Product Change Notification

107406 - 00

Change Notification #: 107406 - 00
Change Title: Intel PRO/10GbE LR Server Adapter, PXLA8591LRG1P5 MM#857392 (Lakeway LR OEM Generic), PRO/10GbE SR Server Adapter, PXLA8591SRG1P5 MM#858966 (Lakeway SR OEM Generic), PRO/10GbE SR Server Adapter, PXLA8591SR MM#858385 (Lakeway SR Retail), and PRO/10GbE LR Server Adapter, PXLA83951LR MM#858389 (Lakeway LR Retail)

Date of Publication: April 4, 2007

Picture of Large, Small and Med sized labels (example shows size of labels only, not exact placement)

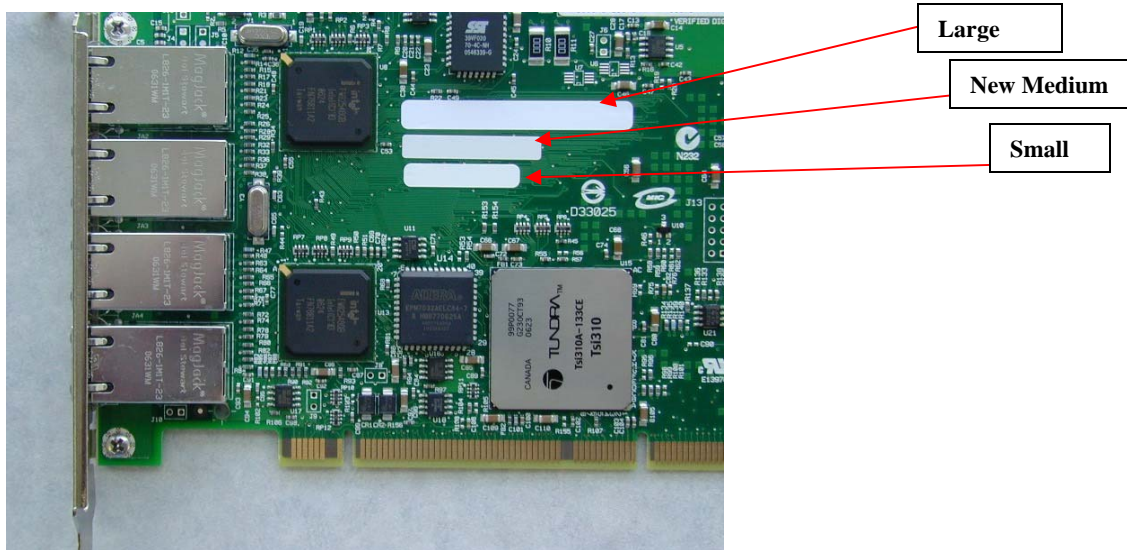
- The 3n1 label, which is placed on the primary side of the adapter in the upper right hand corner, will change from either a Large label size of 2" x .25" or Small label size of 1" x .20" to a Medium label size of 1.2" x 0.20". This will not affect the label data in any way. **Please see picture below.**
- We recommend all customers enable their bar code scanners to Scanning Code 93 for the new Medium sized label.
- The products shown in the Affected Products Table, within this PCN notification, will include the new Medium 3n1 label size.
